# T ECHNICAL INFORMATION

- Subject** ▶ Change of the Bolts for Fixing Motor Housing
- For Models** ▶ HK1800, HK1800L, HK1810
- Country** ▶ All countries
- Description** ▶ The bolts in the subject have been changed as illustrated below.

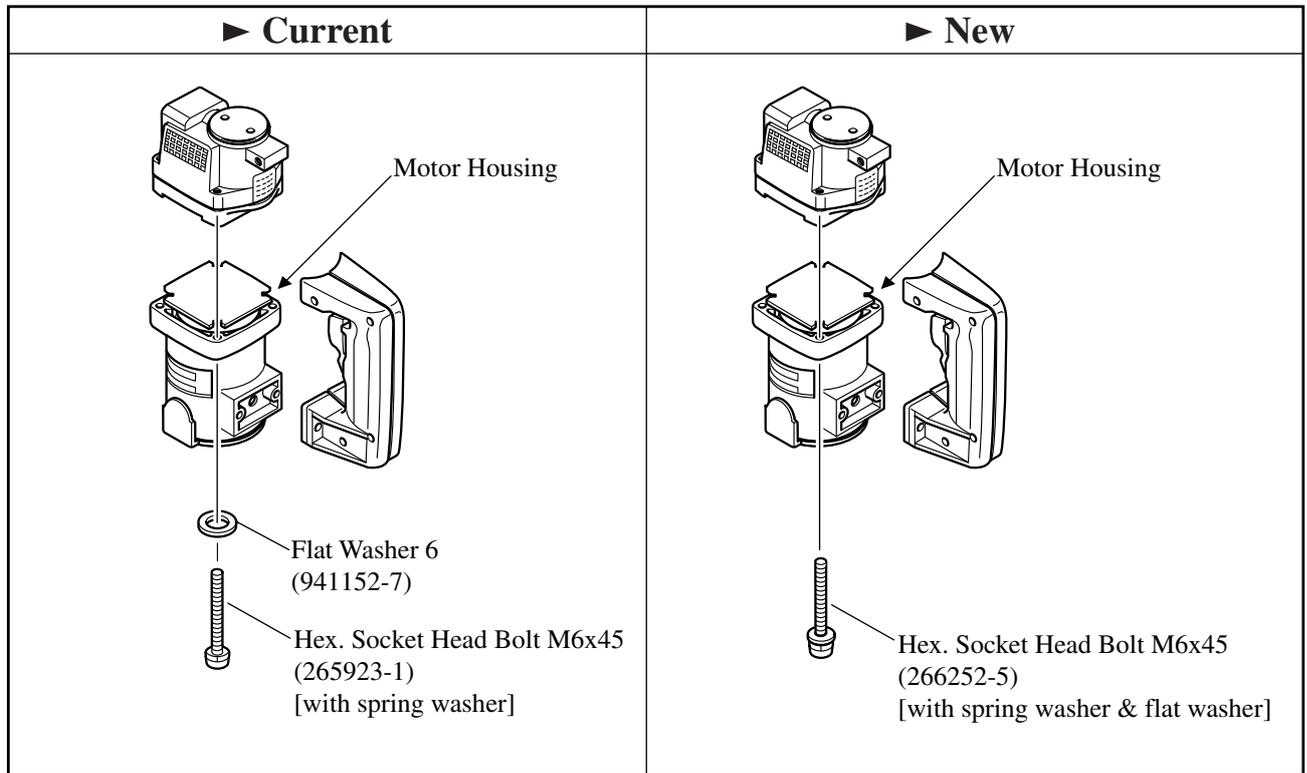
Item No.	Current part	Q'ty	I/C	New part	Q'ty	Note
HK1800: 060 HK1800L: 043 HK1810: 059	Hex. Socket Head Bolt M6x45 ----- 265923-1	4	No	Hex. Socket Head Bolt M6x45 ----- 266252-5	4	↑ Interchangeable as a set ↓
HK1800: 062 HK1800L: 045 HK1810: 061	Flat Washer 6 941152-7 -----	4		-----

- HK1800 : From serial No.57187E (Jan.,2000)
- HK1800L: Discontinued since Apr.,1993
- HK1810 : From serial No.61779E (Jan.,2000)
